Willy ZIMINSKY et al Appl. No. 10/821,975

AMENDMENTS TO THE DRAWINGS

Annotated Sheets Showing Changes to Figures 3, 4 and 6.

Fig. 3 (PRIOR ART)

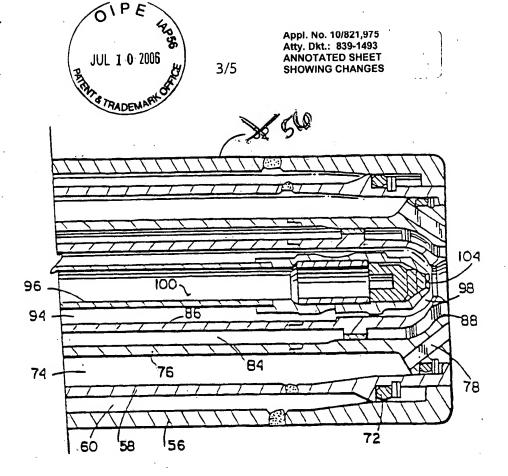
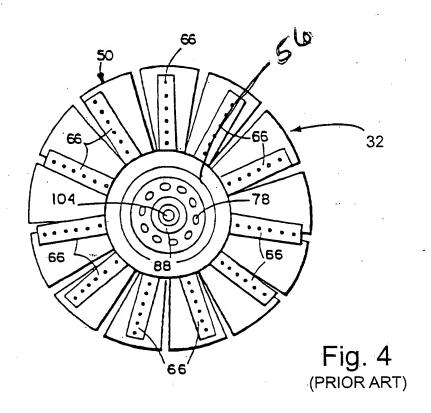
The attached sheet of drawings includes changes to Figures 3, 4 and 6. In amended

Figures 3 and 4, concentric tube 56 of a center fuel injector nozzle is properly labeled. In

Fig. 6

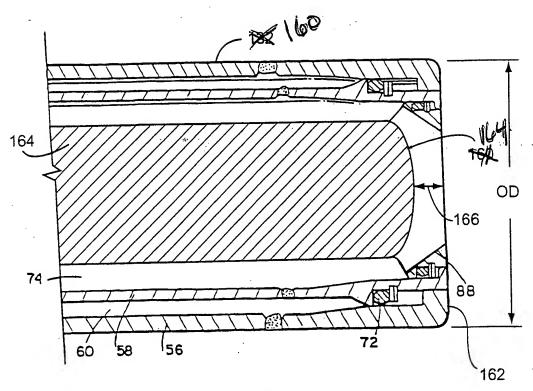
amended Figure 6, the bluff body is properly identified with reference numeral 160 (rather than

center fuel nozzle 132). No new subject matter has been added to this application.

The rejection of claim 4 as being indefinite is traversed because the disclosed embodiment shows a center nozzle having both a plurality of fuel nozzle outlets and a bluff body. For example, Figure 7 shows a center nozzle having a bluff body and fuel injectors on spokes 66. Figure 6 has been amended to properly identify the bluff body that is show in end view in Figure 7.
